* Red text denotes Approved plans to be modified by this application (Stage 2B - Building D and E)

Project
AQUA
STAGE 2B - Building D & E
Panthers North Precinct, Penrith
Sydney NSW Australia

SECTION 4.55
Drawing Title

S4.55 SCHEDULE OF AMENDMENTS
Basement:

FLOOR PLANS
Drawing Title
LEVEL 01 FLOOR PLAN

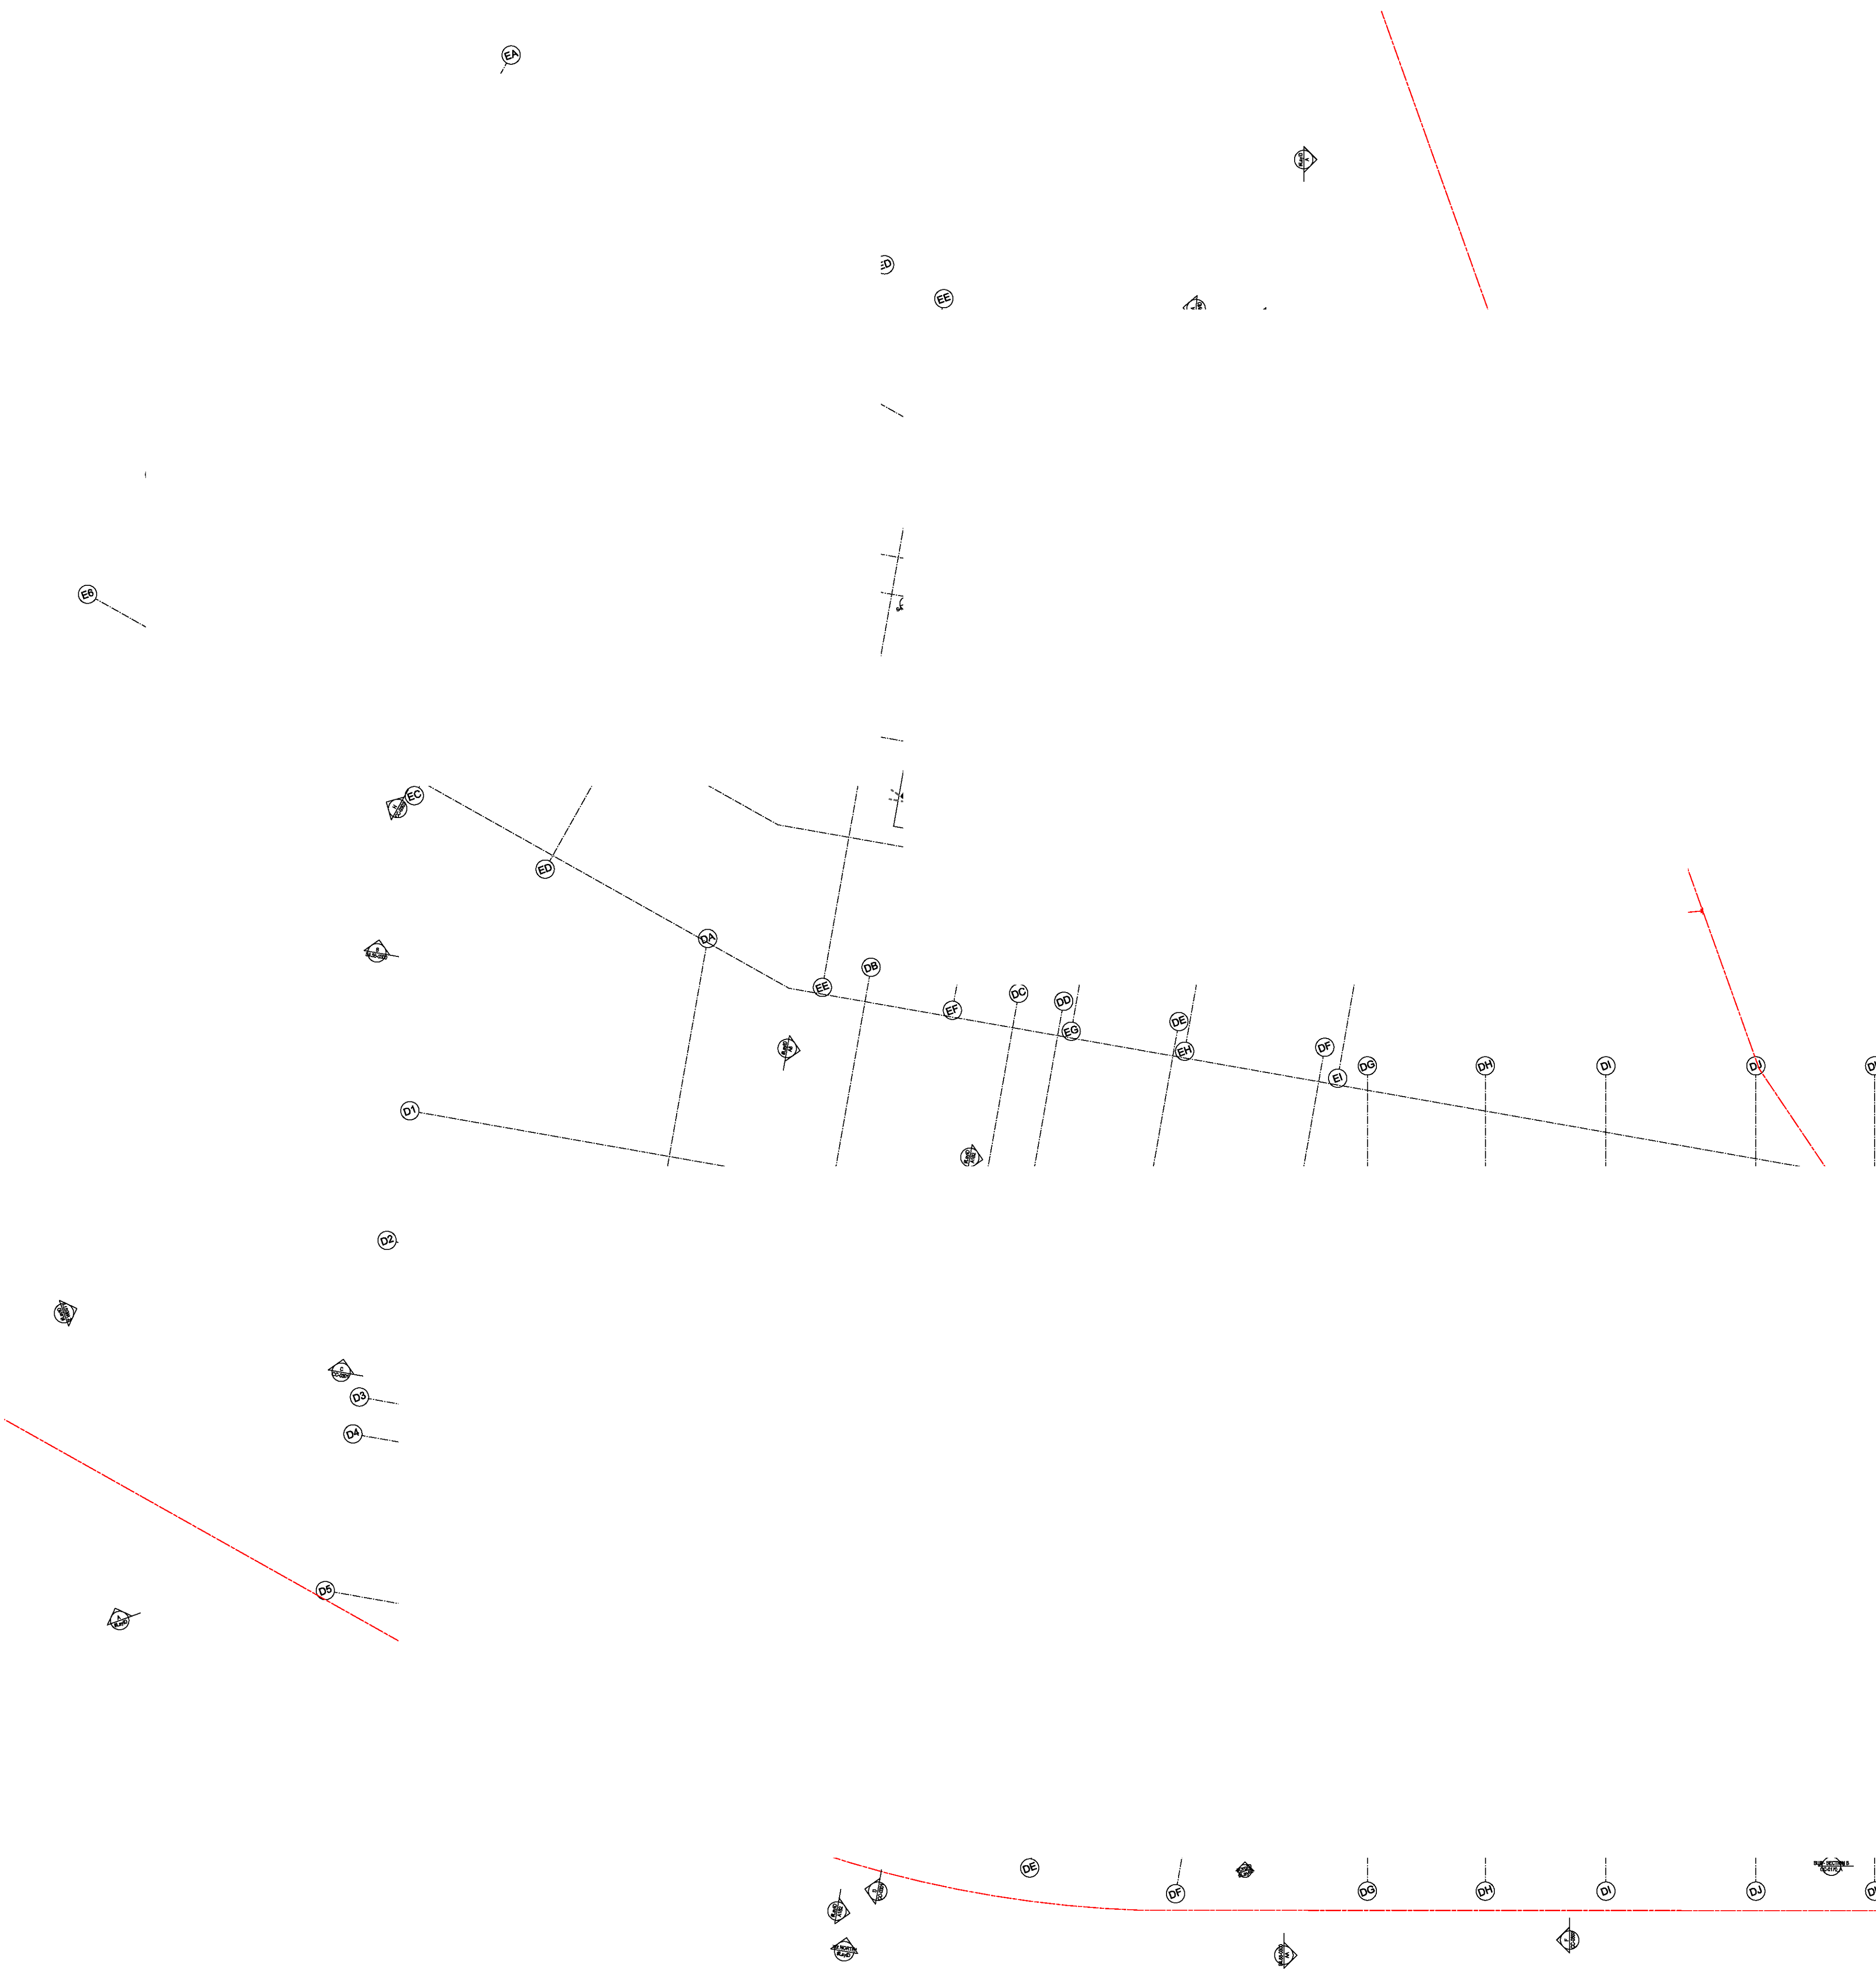
S4.55 SCHEDULE OF AMENDMENTS
Level 01:

- inclusion of adaptable units
- Building D West raised RL 30,600 to 30,750
- Building D East raised RL 30,600 to 30,750
- Building E raised RL 29,850 to 30,750

FLOOR PLANS
Drawing Title
LEVEL 02 FLOOR PLAN

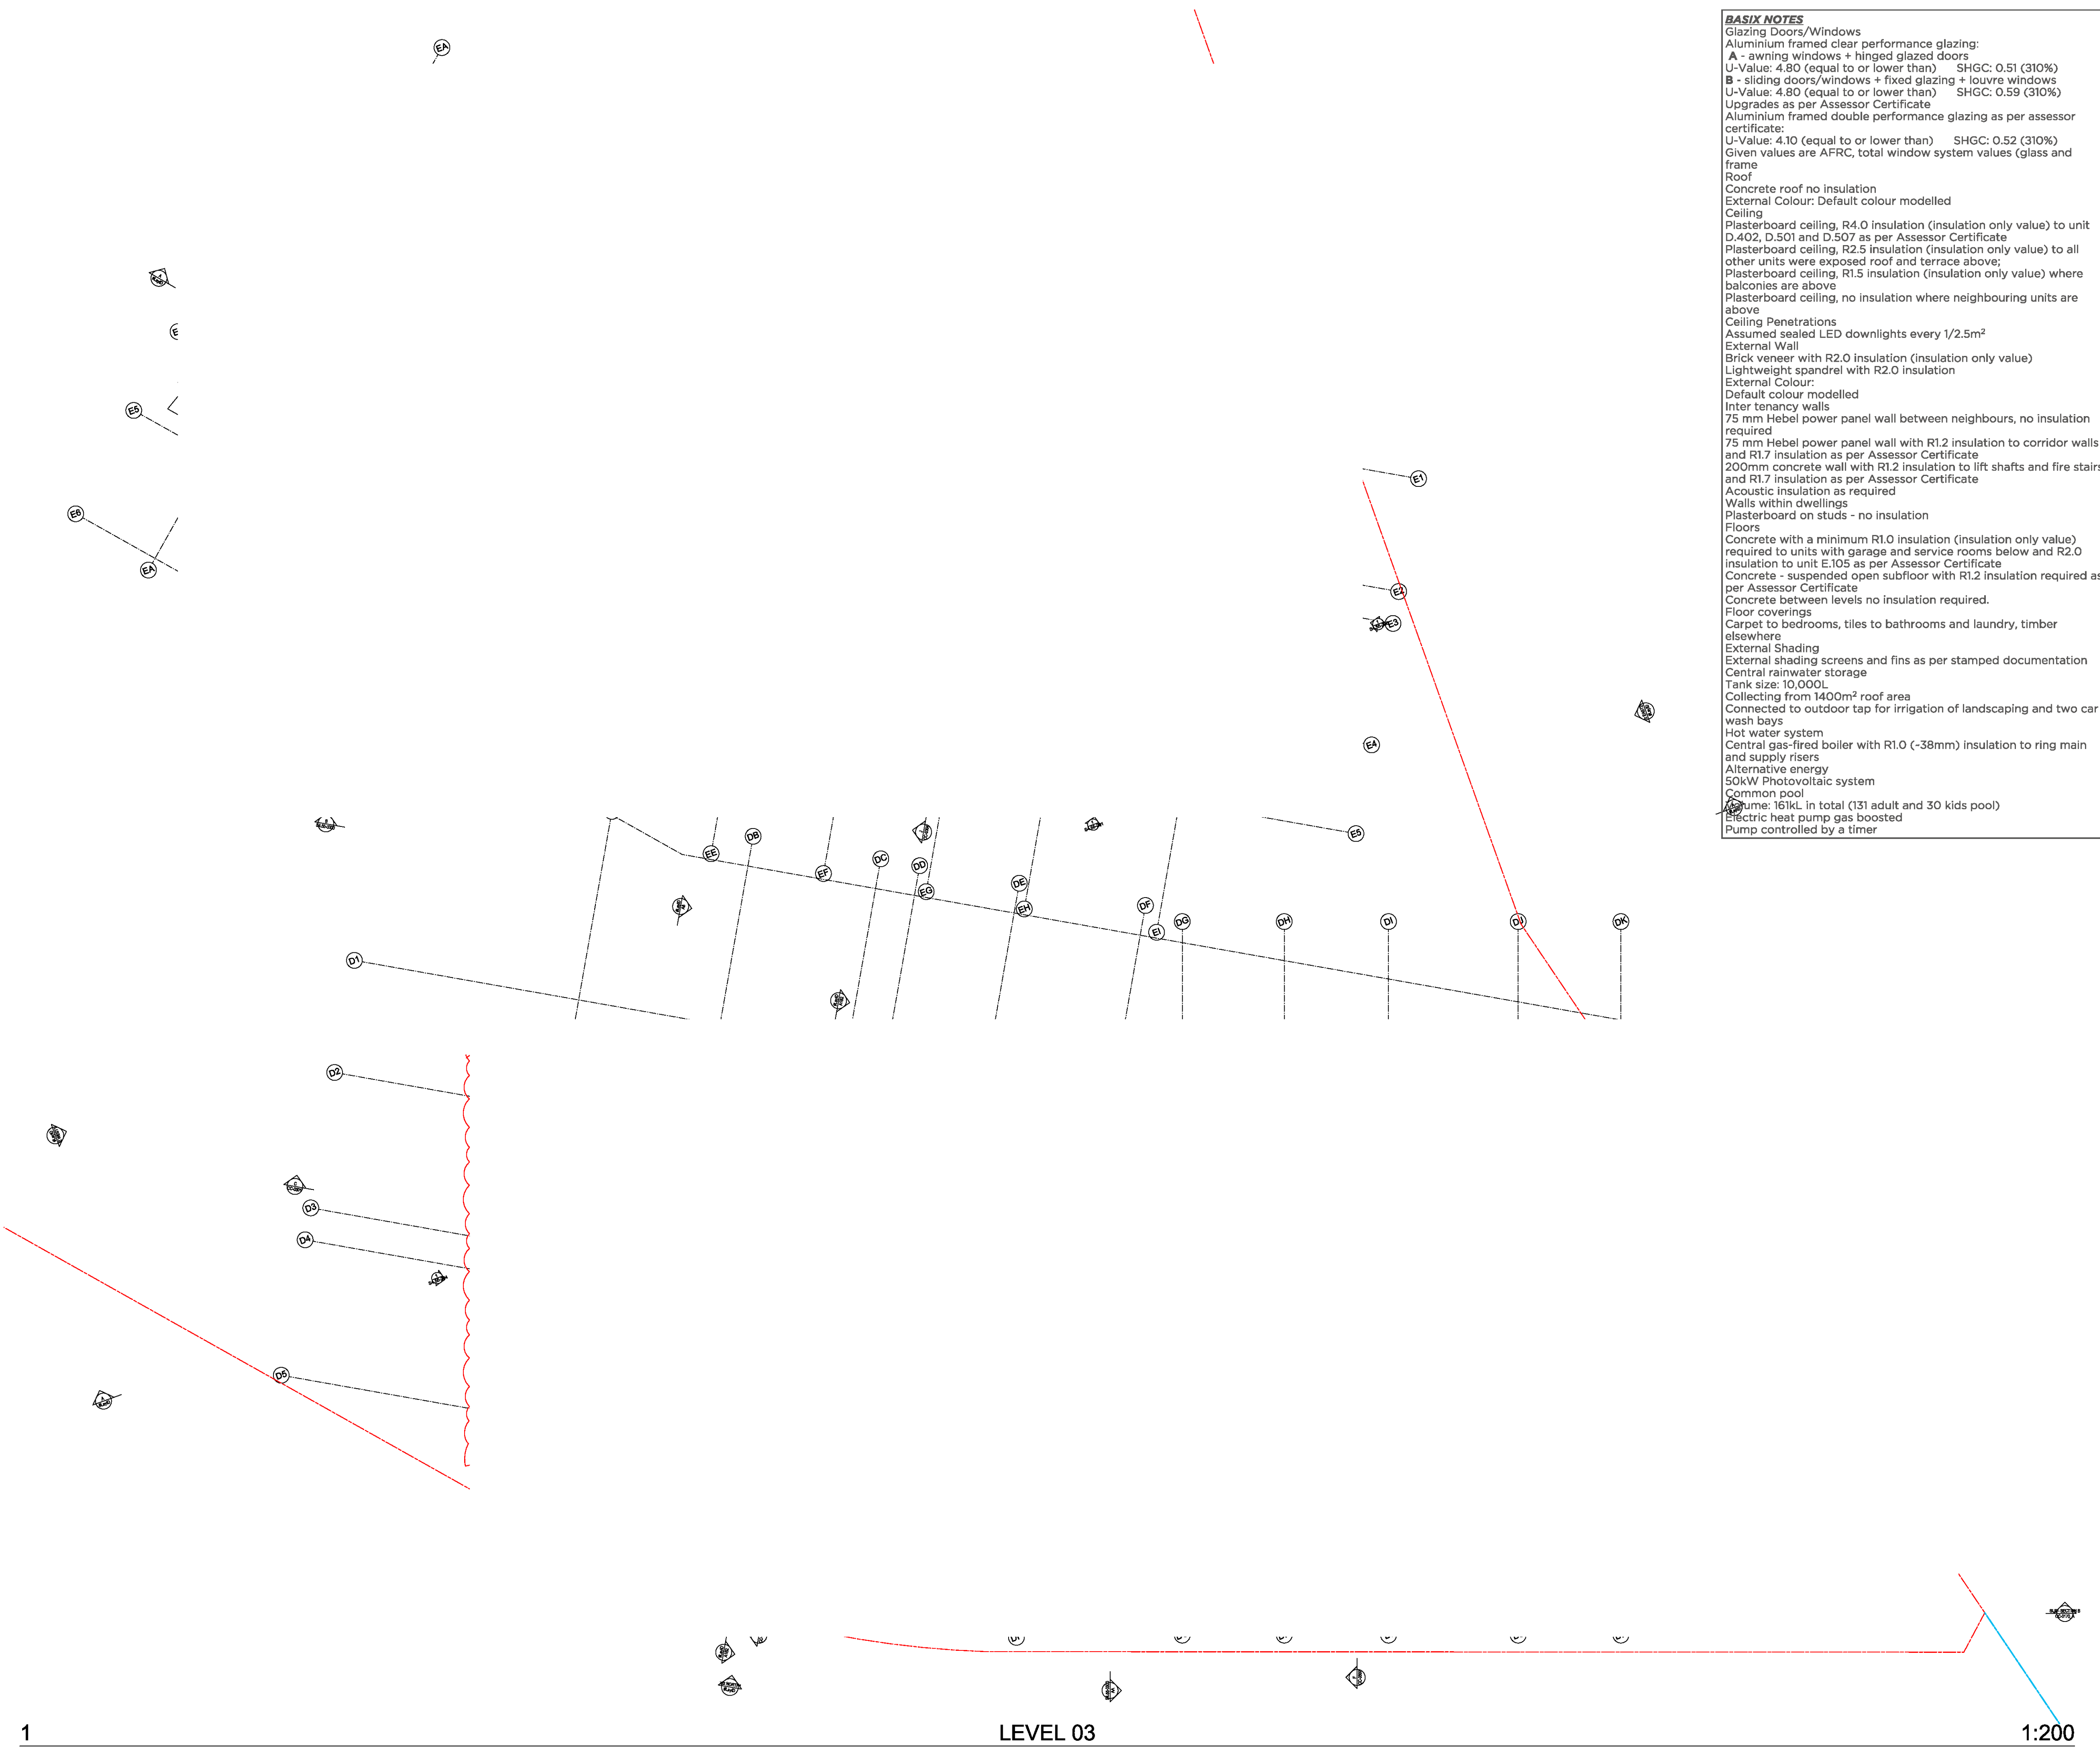
S4.55 SCHEDULE OF AMENDMENTS
Level 02:

- Inclusion of adaptable units
- Building D West raised RL 33,700 to 33,850
- Building D East rasied RL 33,700 to 33,850
- Building E raised RL 32,950 to 33,850
- Units 305a & 305b to be 2 seperate 1B units as per GF and L1 approved sketch
